## Appendix W

Note responding to queries raised at planning committee on 19<sup>th</sup> July 2018.

## Introduction

The following document addresses the points raised at the Planning Committee of the 19<sup>th</sup> July 2018 and should be read in conjunction with the updated Construction Management Plan and Appendices. These can be viewed at: <https://creeksidewharf.london/public-consultation/theatre-square/scheme/>.

**Fig. 1 – Site Constraints**

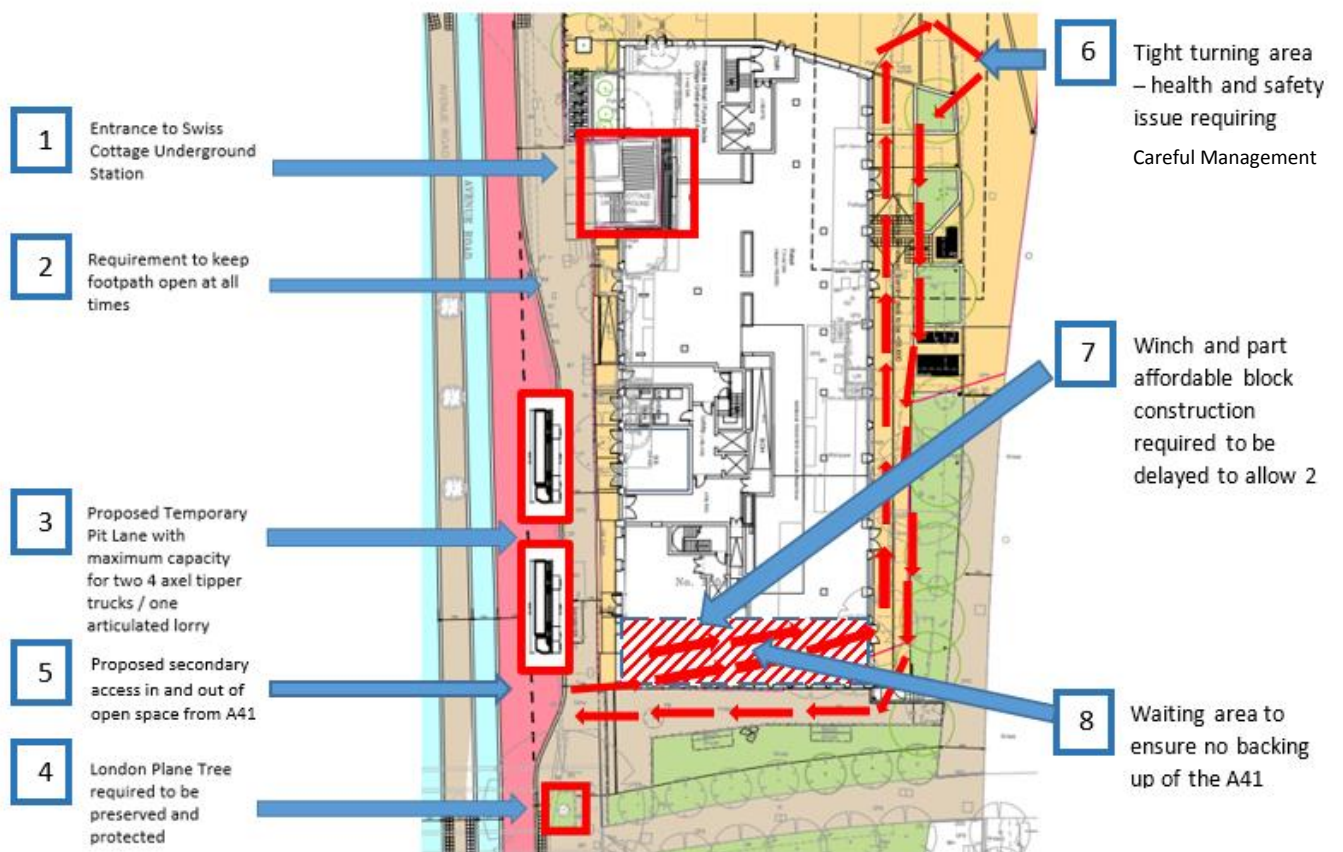
A single point of access off the A41 via the “Pit Lane” has been discounted as impractical due to the impacts on construction logistics resulting in a prolongation of the programme by up to an estimated 2 years. This is due to two main reasons, namely:

The “Pit Lane” is restricted to 28m in length, **(Point 3)** due to the London plane tree **(Point 4)** and bus stop to south, and the Swiss Cottage London Underground entrance **(Point 1)** to the north, resulting in it having a limited capacity of 48 vehicles per day, therefore limiting the time needed to load and unload materials from each vehicle.

Therefore, having a secondary access point off the A41 **(Point 5)** is critical to minimising the negative impacts.

As can be seen in **(Point 6 and 7)**, the logistics of having 2-way vehicle movement within a constrained site will be challenging and will require the delay of the construction of the Winch Community space and part of the affordable block until the rest of the site is complete **(Point 7)**, causing a delay in the overall programme.

The use of a 2-way route through this area **(Point 8)** will result in a reduced vehicle capacity on-site compared with a single route through the site due to the increased requirements to pause vehicles whilst others are manoeuvred into position and turned around on-site causing further delay and an increased health and safety risk.

Fig. 2 – Demolition Phase

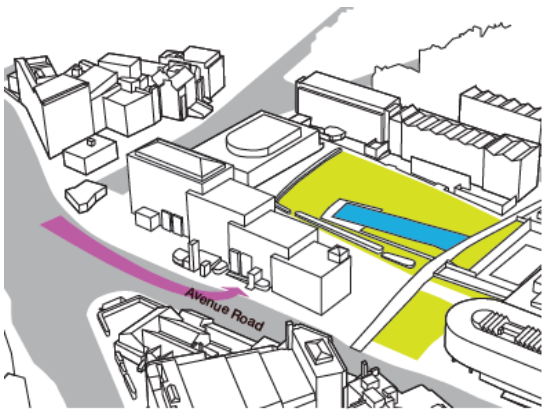
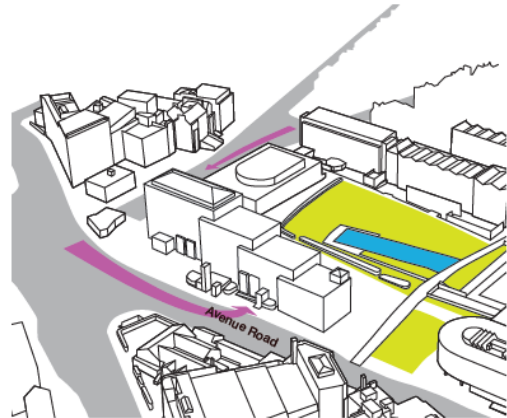
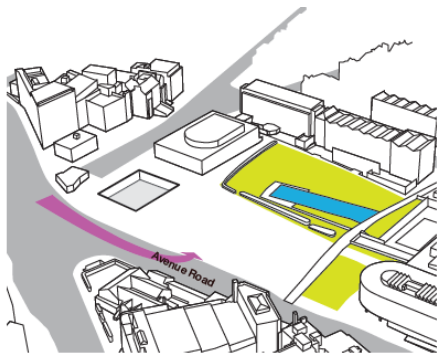
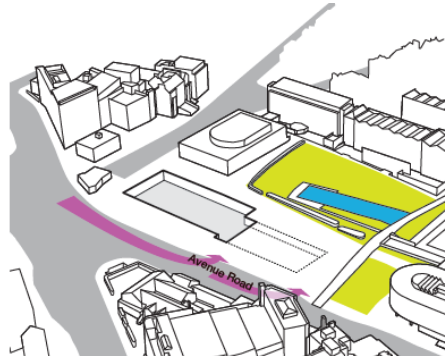
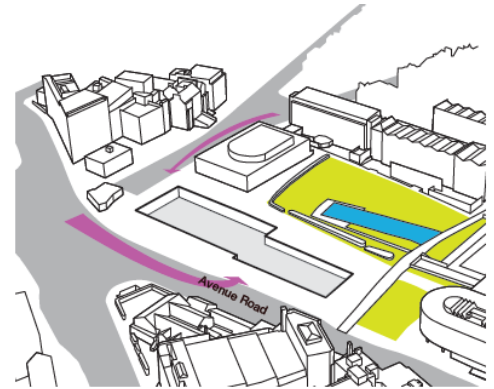
- Single access point will prolong demolition due to the constraints of accessing the full site and the limits of vehicles being able to remove the waste from site
- Requirement to block lanes off the A41 to allow outrigger lorries access to site impacting bus movements
- High probability of congestion of public highway and conflict with the free flow of vehicle traffic to the detriment of highway safety
- Difficulty to phase demolition works around theatre events as work can only progress from south to north

- Multiple access points allows swifter more efficient demolition reducing impact on local stakeholders
- No requirement for closure of any lanes of the A41
- Ease to programme demolition works around theatre schedule as work can be scheduled to the north or to the south of the site due to 2 entry and egress points depending upon the performance schedules

**Fig. 3 – Basement and Enabling Phase**

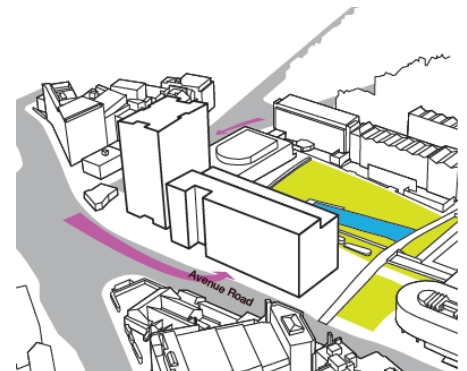
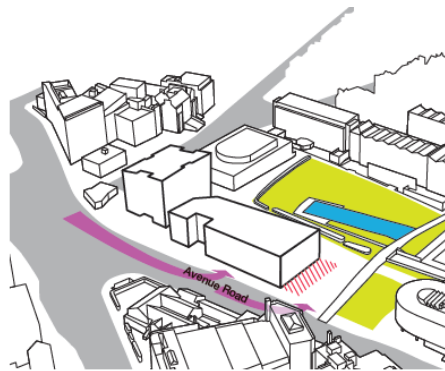
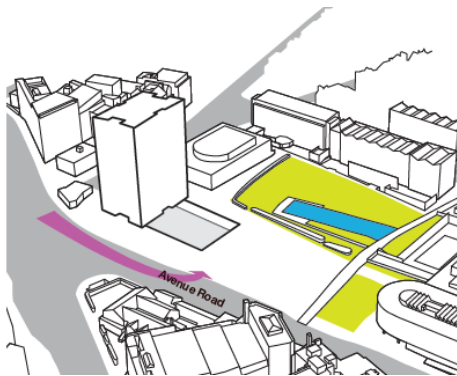
- Impact of restricted access limits the ability to run concurrent activities
- Single point access requires all demolition activities completing before the commencement of any substructure works, which includes enabling and piling activities
- Substructure work limited to tower only
- Single access points leads to a high probability of vehicles backing up onto the A41

- Two access points off the A41 reduces the risk of vehicles backing up onto the A41 if the Pit Lane reaches capacity but is not TfL's preferred solution
- Substructure works can be extended but not to the full extent of the area

- Multiple access points allows concurrent activities, resulting in a more efficient excavation phase
- Substructure works may commence on both blocks simultaneously
- No backing up of A41 or requirement to shut any lanes

**Fig. 5 – Construction Phase Continued**

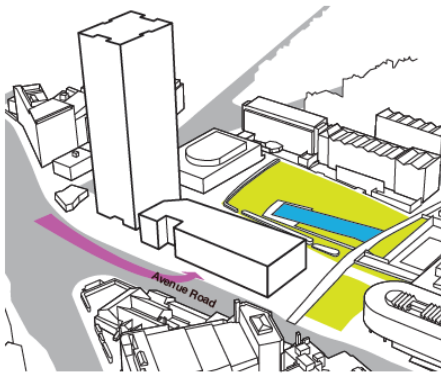
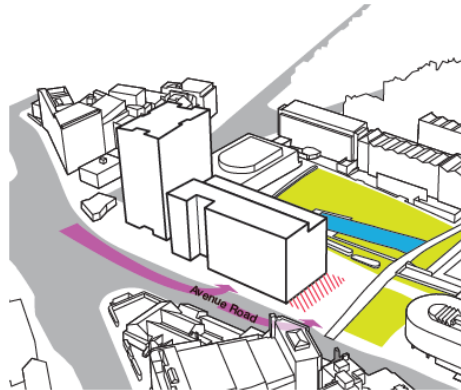
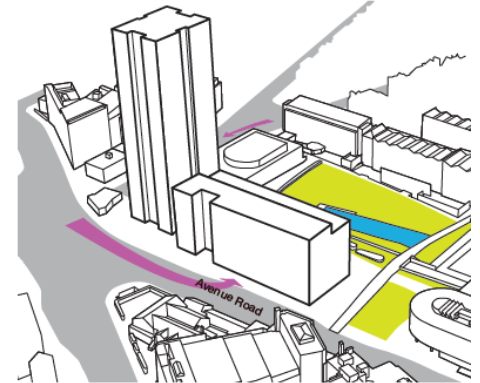
- Fit out of tower is undertaken prior to the commencement of the lower block due to the constraints of a single access point
- The increased pressure associated with operating in a more constrained environment increases the health and safety risk associated with delivering the project
- The delay in fitting out the lower block results in a prolongation of the programme

- Access off the A41 means superstructure works are delayed to Block B
- But fit out works to the tower and the majority of affordable element of Block B can commence earlier and can be undertaken concurrently
- Construction and fit out to the Winch area and remaining affordable block (hatched red) delayed to allow vehicle access to the site
- Increased risk of tailbacks on the A41 due to the requirement for scissor gate access to the site resulting in possible delays accessing off the A41 across pedestrian paths
- Health and Safety risk associated with delivering project with such constrained access points
- A quicker programme than the sole use of the pit lane, but the delay to the Winch completion extends the programme

- Multiple access points results in superstructure works finishing faster
- Fit out works for tower can commence earlier, with Block B fit out being coordinated to complete at the same time as completion of Block A resulting in an overall quicker programme

**Fig. 7 – Draft CMP 2014 –Approved Planning Documents, app. Ref. 2014/1617/P**

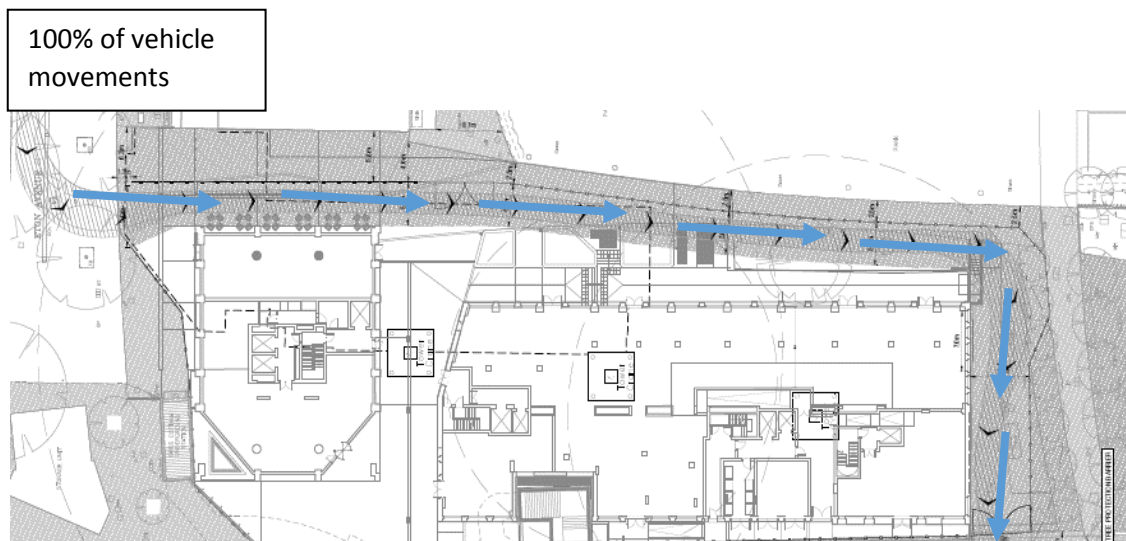
The draft CMP submitted at planning application stage and forming part of the approved planning documents in 2016 (**Appendix X**) shows 100% of construction vehicles accessing site via Winchester Road and Eton Avenue, as per the below diagram.

**Fig. 10 – Proposed root mitigation measures**

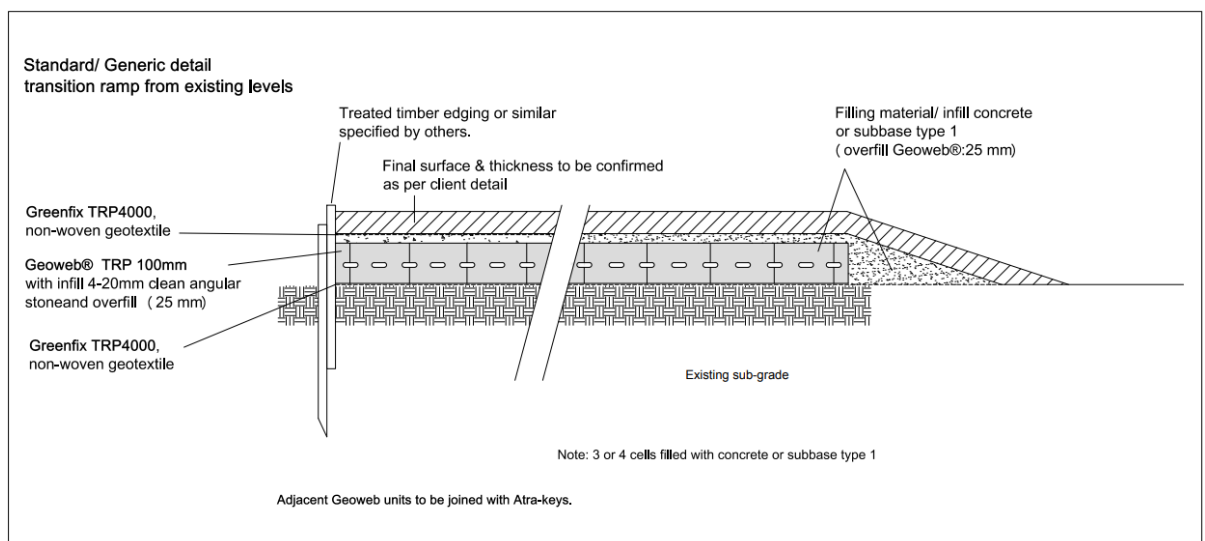
The London Plane tree on the pavement of the A41 is not within Essential Living’s demise, and is a Highway Tree. However this tree will be a priority to protect due to its proximity to vehicle movements. We are committed to its protection and will seek full agreement to our protection measures proposed as part of the CMP.

Essential Living will commit to further exploratory research on tree root zones beneath the pavement surfacing and the appropriate barriers, matting and/or bridging to be put in place in order to protect this tree.

A full method statement will be provided with measures likely to include a transition ramp with matting (as shown below) to protect the tree roots along with tree barriers to protect the trunk.

**Fig. 12 – Proposed Market Alignment**

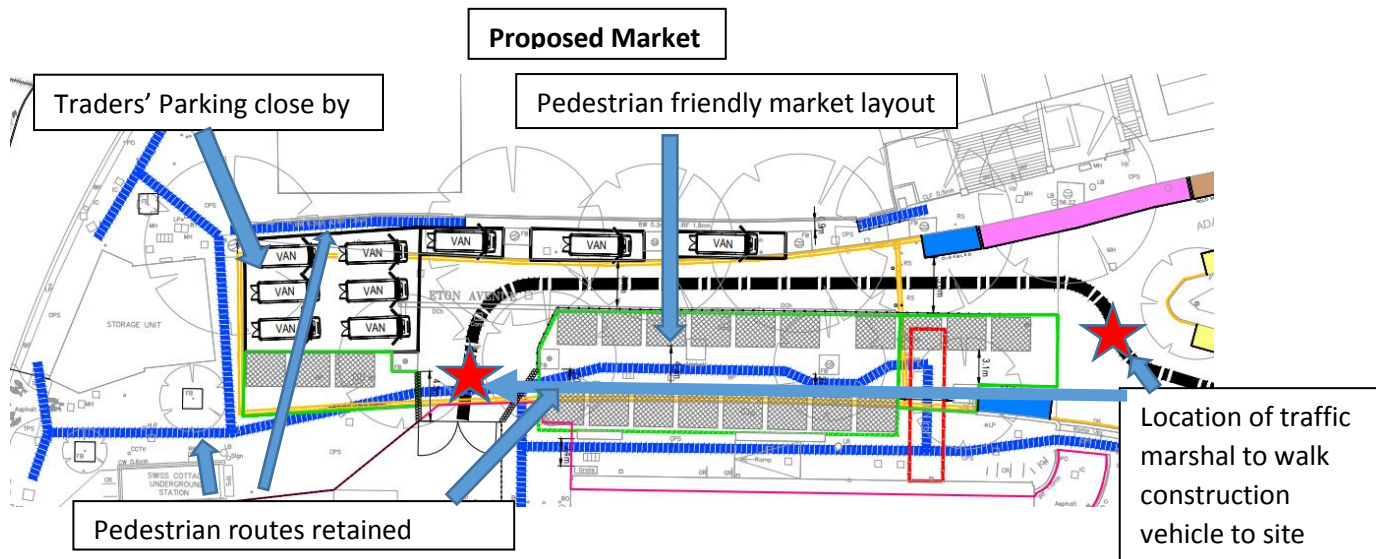
The proposal seeks to create a pedestrian friendly market ‘street’ with the market traders’ vehicles parked away from the stalls. To effectively implement this, EL has undertaken to take steps to provide electricity supply to the stalls.

This amended market layout will be permanent in order to maintain a clear access route to the site for emergency services as well as Camden Council's park maintenance team post demolition phase.

**Fig. 13 – Alternative Options Considered**

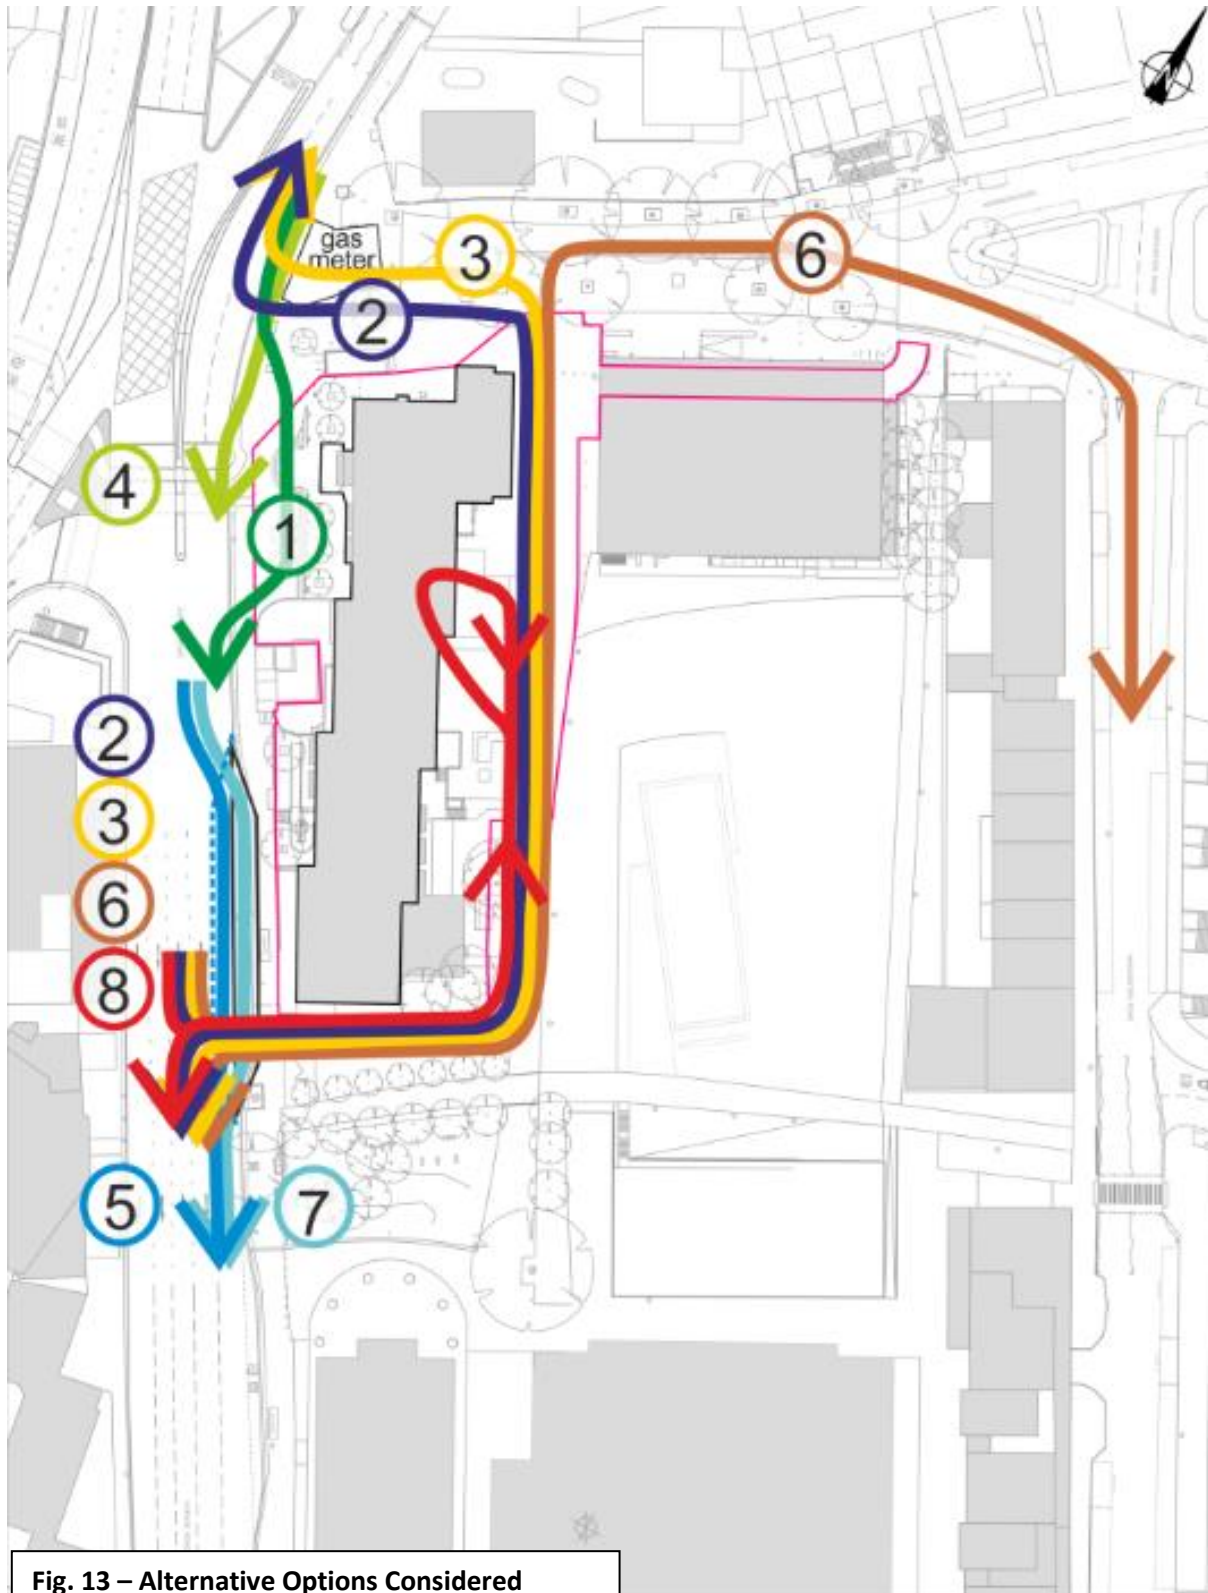
Vehicle loading area located within the site between the two London Underground (LU) station entrances on Avenue Road. The access route would involve vehicles travelling down College Crescent rather than directly off the A41 resulting in an increased chance of vehicles backing up the A41 and blocking of buses whilst they turn into College Crescent (currently a bus only turn).

This option was rejected because of safety concerns related the high level of pedestrian and cycle activity at the existing and proposed CS11 crossings.

This was recommended to be retained as a construction vehicle route but supported by a Pit Lane on the A41 (see Option 7) to substantially reduce the number of vehicle movements along Winchester Road and Eton Avenue.

This option is recommended as the sites' main construction vehicle access point (for either the Draft CMP 2018 vehicle routing proposal or the Hybrid Option) for the following reasons:

Recommended to provide a secondary access and egress point to the site via the A41, which will be used to avoid any disruption or increased road safety concerns as a result of vehicles being unable to access the "Pit Lane" for unforeseen circumstances.

This secondary access point is constrained due to the existing basement, new building cores and site boundary and therefore requires the delay in the construction of part the Winch Community area and part of the Affordable Block to allow a 2 way access and layby area on the site. This will impact on the programme compared with a single route through the site (via Winchester Road).
